**MEMORANDUM – REDACTED VERSION – JULY 19, 2007**

**Subject:** Update of Current Knowledge Regarding the State of Integrity of OCNCS Drywell Liner and Comments Pertaining to Aging Management Thereof

**Subject: Review of Fitness for Service Assessment of Oyster Creek Dry Well  
on the Basis of Extended Data Analysis**

Figure 4

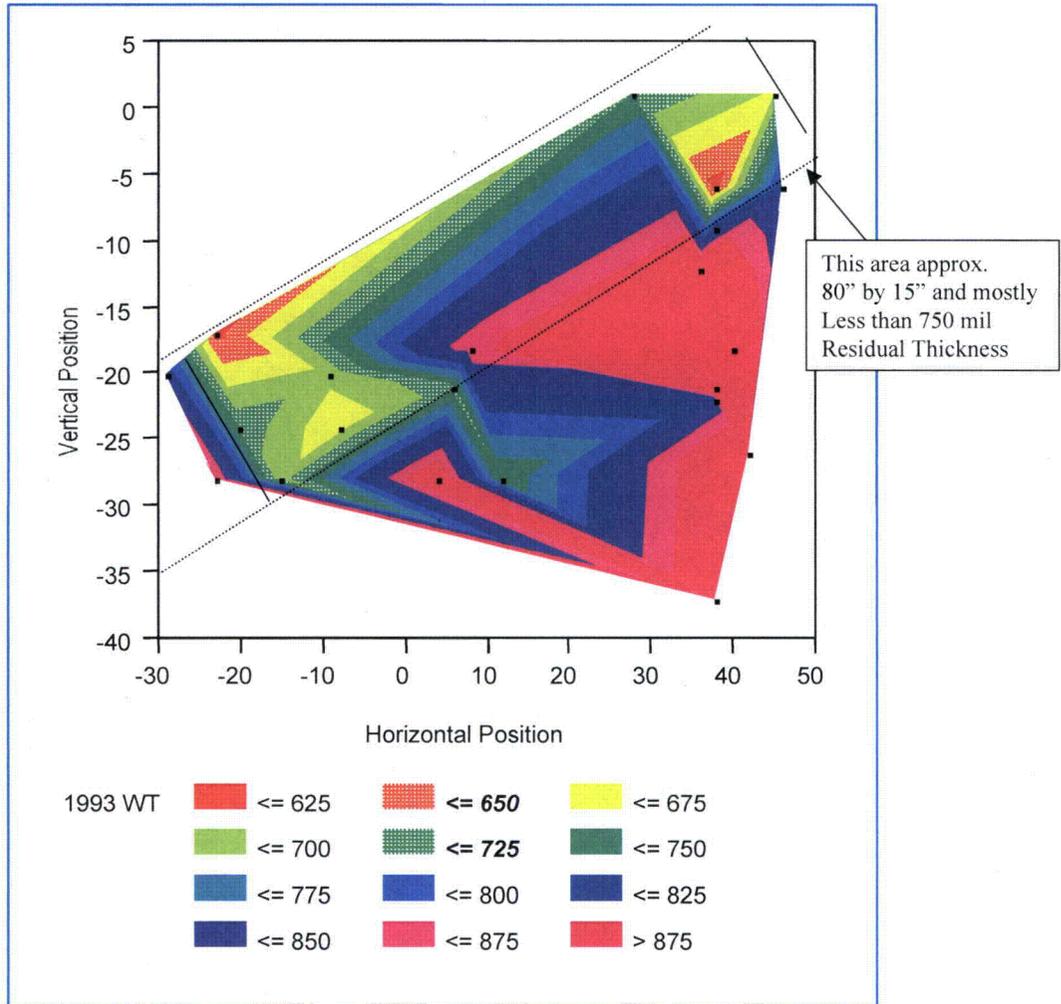
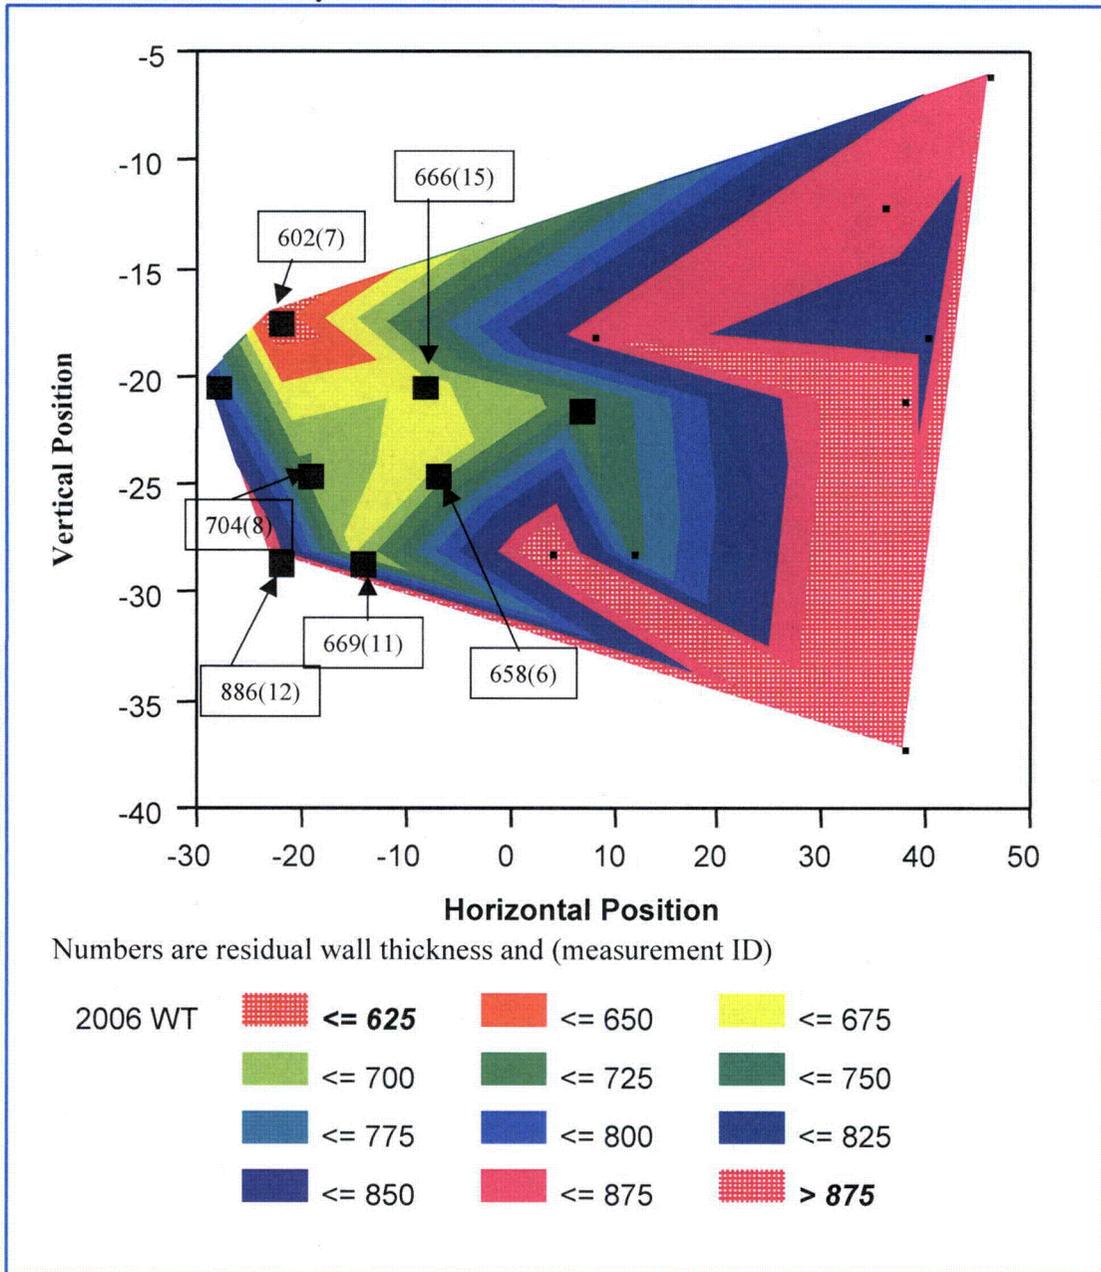
**Figures 4 and 5** show the contours for Bay 13, 1992 and 2006 data, respectively. Here large areas exist with wall thicknesses below 700 mils and at least two seemingly unconnected areas where the residual wall thickness is less than 650 mils. It could be argued that those heavily corroded areas are less than 1 square foot and therefore are still acceptable according to the 636 mil criterion. However, the heavily corroded area on the left hand side (-20, -20) has not been further explored. One therefore does not know whether it might extend further. Similarly, the area on the right ((40, -7), clearly showing a fairly deep pit, was not further explored and was not even measured in 2006. While in Bay 1 the bathtub ring was at elevation -20 to -25 (from the reference point) in Bay 13 there is no clearly prominent bathtub ring. This may be because it was not there, but it may also be because the measurements were not extended toward elevation -15 and -10. We are therefore left with a great uncertainty as to the true extension of the damage in this Bay.

Figure 6

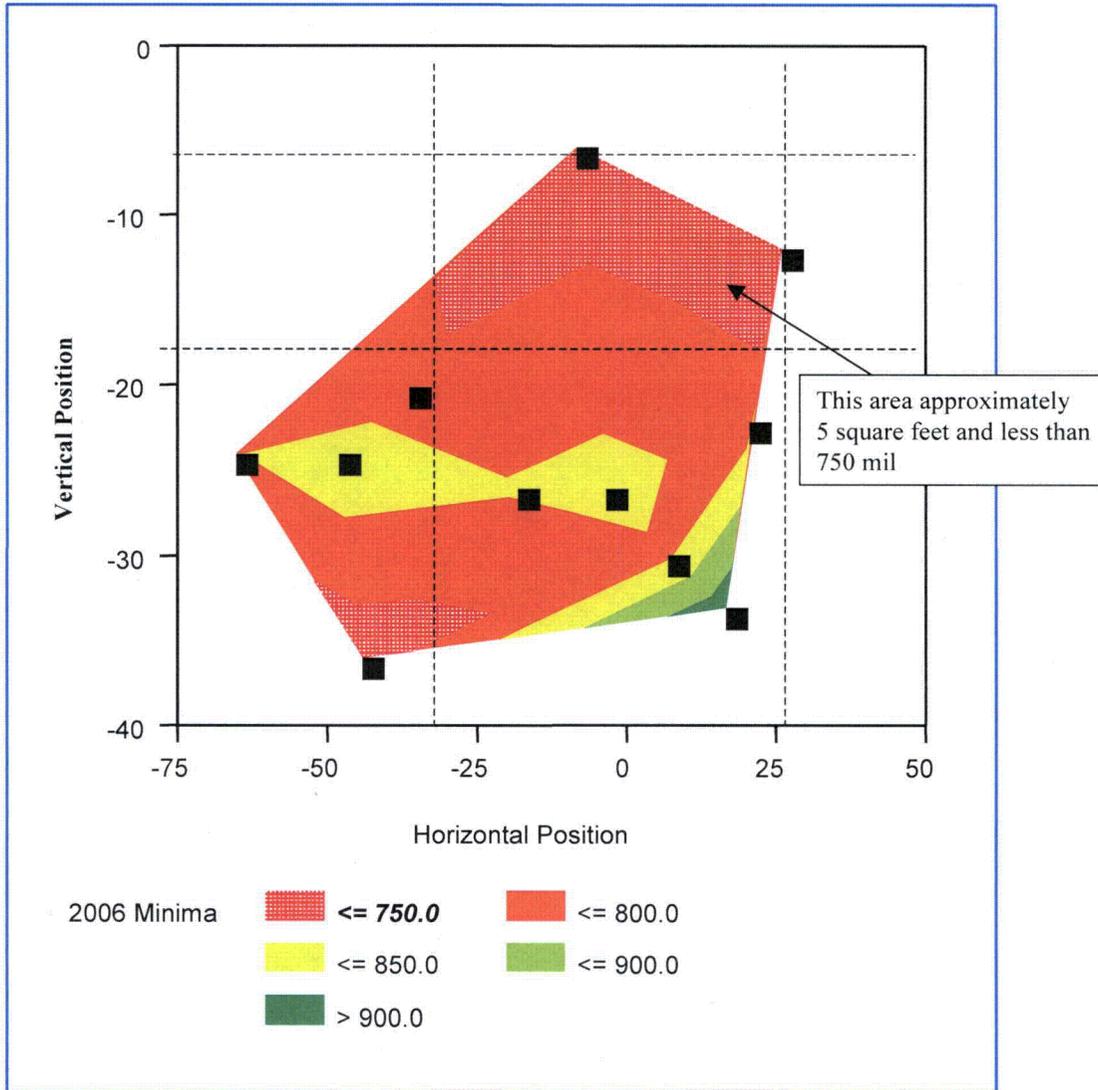
**Figure 6** shows the contours for Bay 15. There is a heavily corroded area at elevation -10 with an extension of 1 ft by about 4.5 feet. However, this area was explored only with 2 measurements and was not extended beyond about 2 feet either side of the centerline. It appears that the majority of the measurements occurred in the non-corroded zones. Interestingly there appears some serious corrosion near the sandbed bottom, but the occurrence was not further explored either.

Figure 7

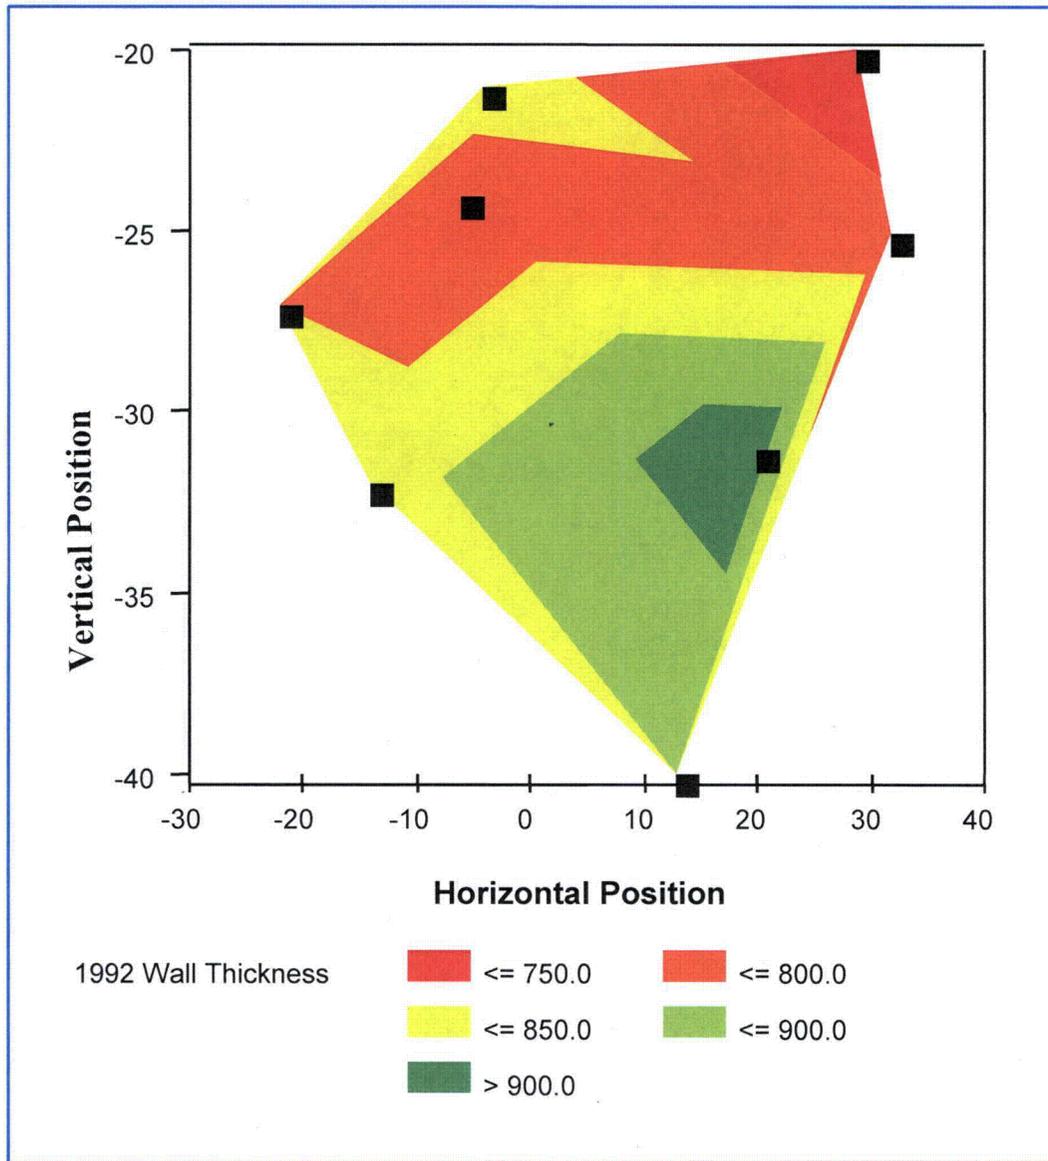
**Figure 7** shows the contours for Bay 11. Again there is a suggestion of severe corrosion at elevation -20 and no further exploration into the bathtub ring area. Once again, the extent of this area is highly uncertain because it was not further defined by additional UT measurements.
